RED DASHED AREA DELINEATES LIMITS OF PROPOSED PLANNED DEVELOPMENT (PD). THIS INCLUDES PARCEL 1, 2 & 3 OF THE ORIGINAL SUBDIVISION. ALL LOTS MUST BE INCLUDED IN THE PD IN ORDER TO MEET THE OPEN SPACE REQUIREMENT.

PD EXHIBIT A
November 28, 2018

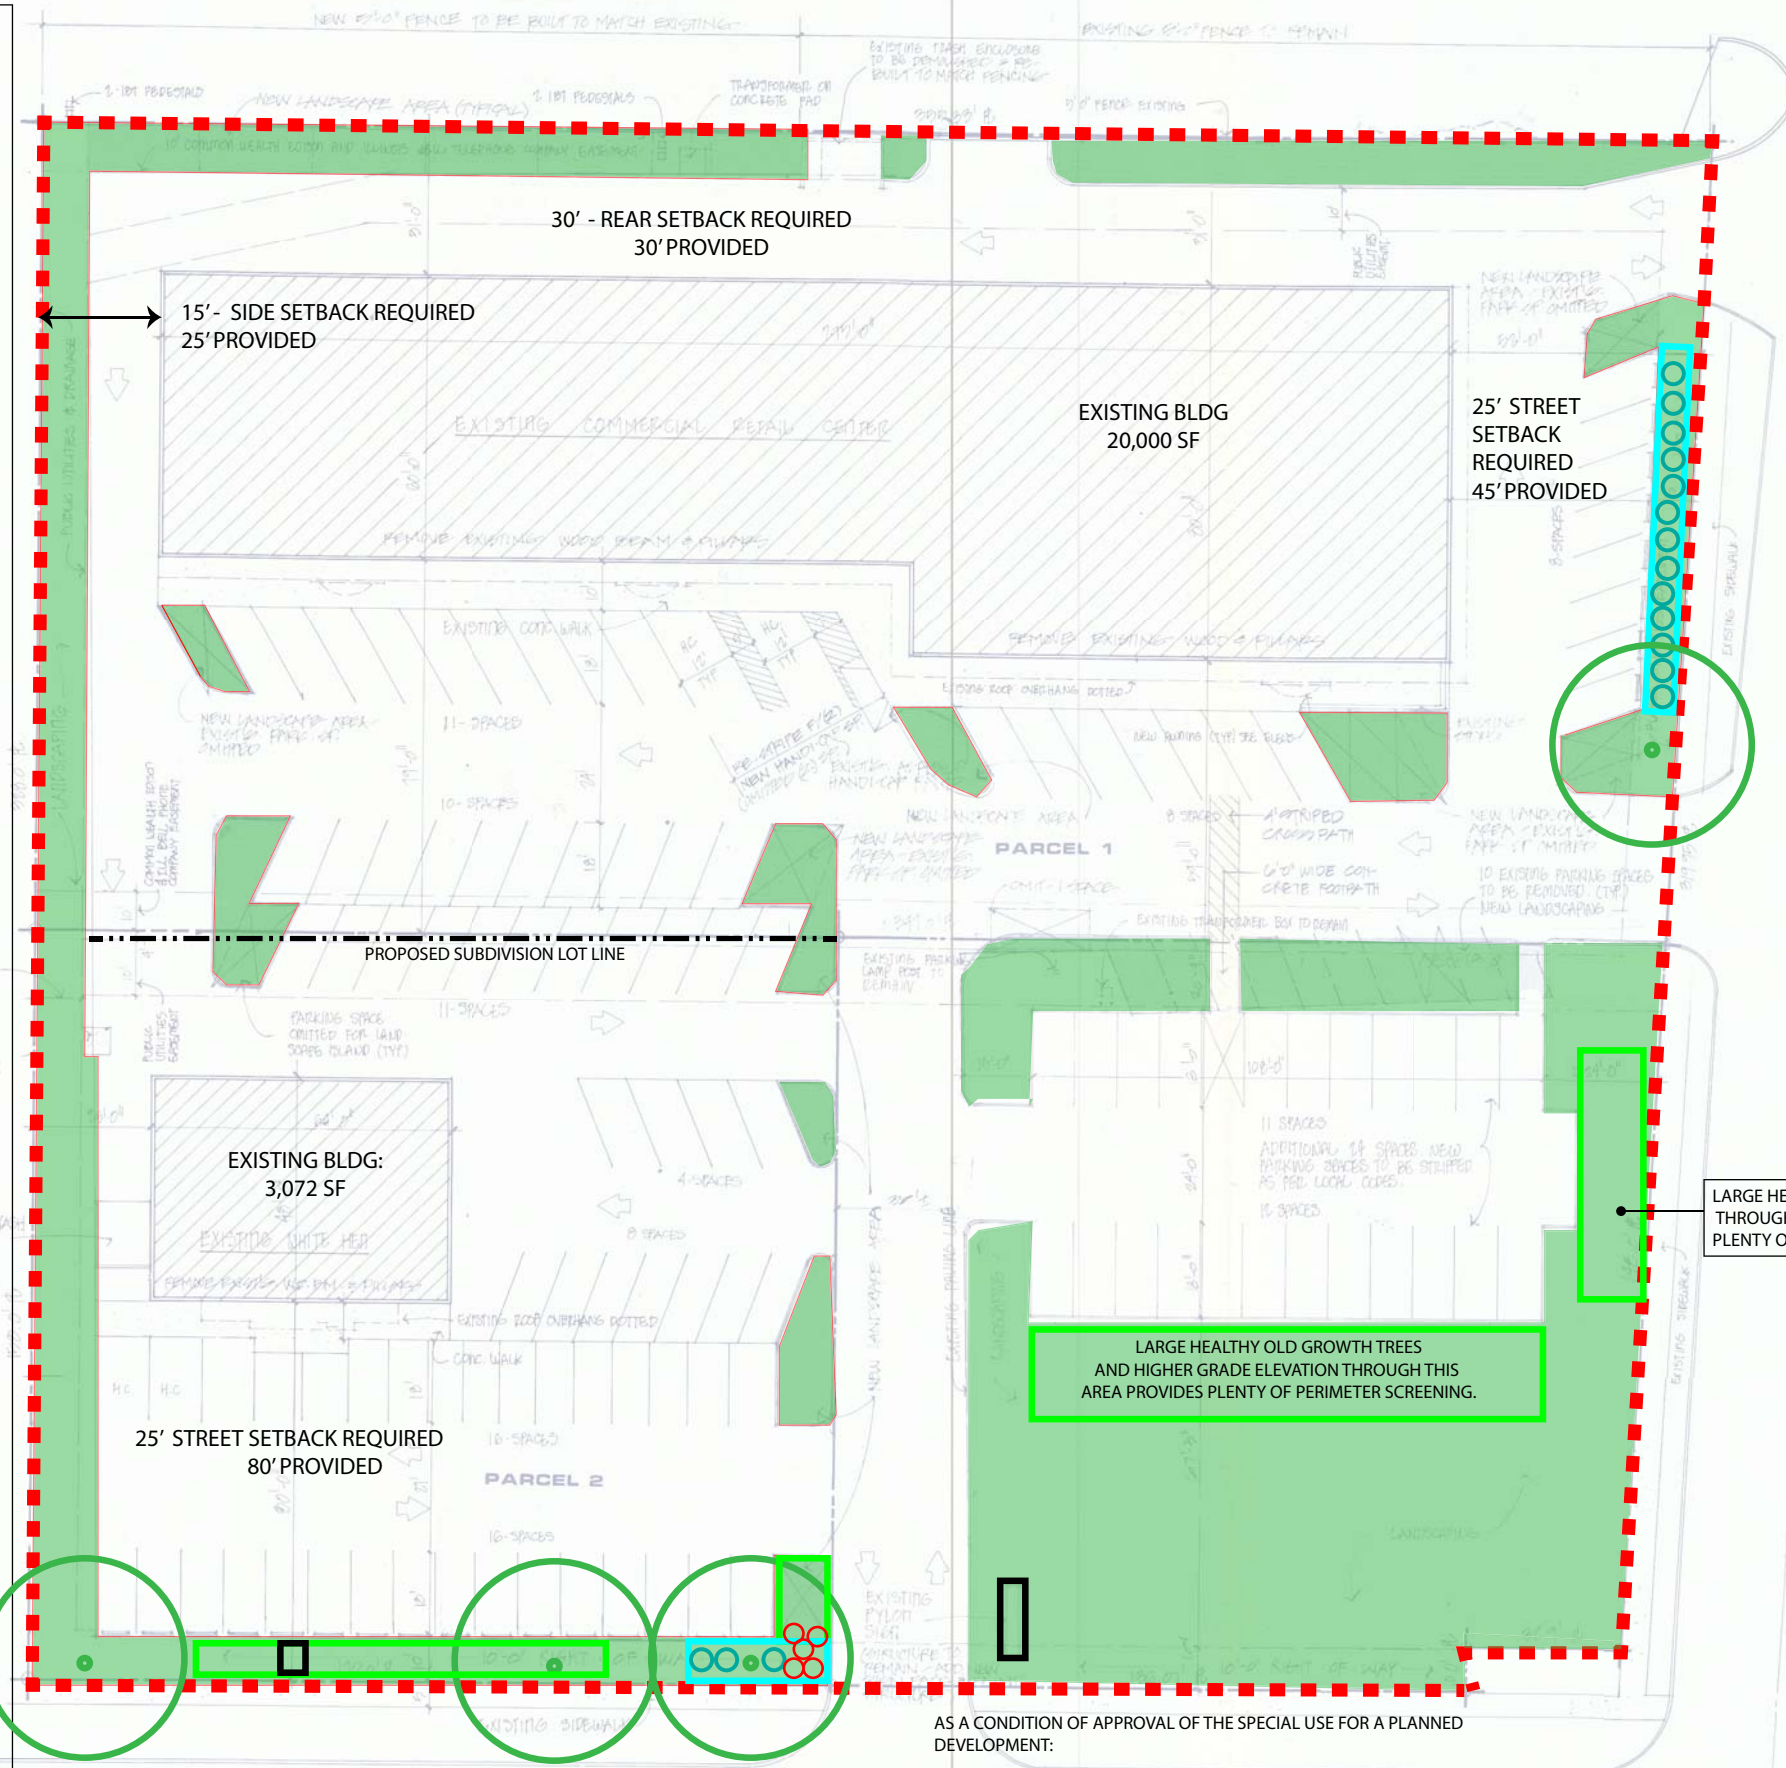
EXISTING PYLON SIGNS TO BE REPLACED WITH COMPLIANT SIGNAGE WITHIN 3 YEARS OF BOARD APPROVAL. SITE LIGHTING WILL ALSO BE REQUIRED TO BE BROUGHT INTO COMPLIANCE WITHIN 3 YEARS.

EXISTING LANDSCAPE AREA TO BE RETAINED, TRIMMING OF PLANT MATERIAL WILL BE REQUIRED.

AREA OF LANDSCAPING TO BE UPGRADED. MINIMUM SIZE OF PLANT MATERIAL TO BE 3' HIGH AT MATURITY.

AS A CONDITION OF APPROVAL OF THE SPECIAL USE FOR A PLANNED DEVELOPMENT:
FILLING OF POTHOLES, REPAIR/REPLACEMENT OF BROKEN CURB, RE-SEAL/RE-STRIPE OF PARKING LOT, PARKING LOT AND BUILDING LIGHTING MAINTENANCE AND LANDSCAPE IMPROVMENTS MUST BE COMPLETED WITHIN 1 YEAR OR BEFORE THE END OF THE FIRST CONSTRUCTION SEASON FOLLOWING BOARD APPROVAL, WHICHEVER COMES FIRST.
A COMPLETE MILLING AND RESURFACING OF PARKING LOT TO BE COMPLETED WITHIN 2 YEARS OF BOARD APPROVAL.
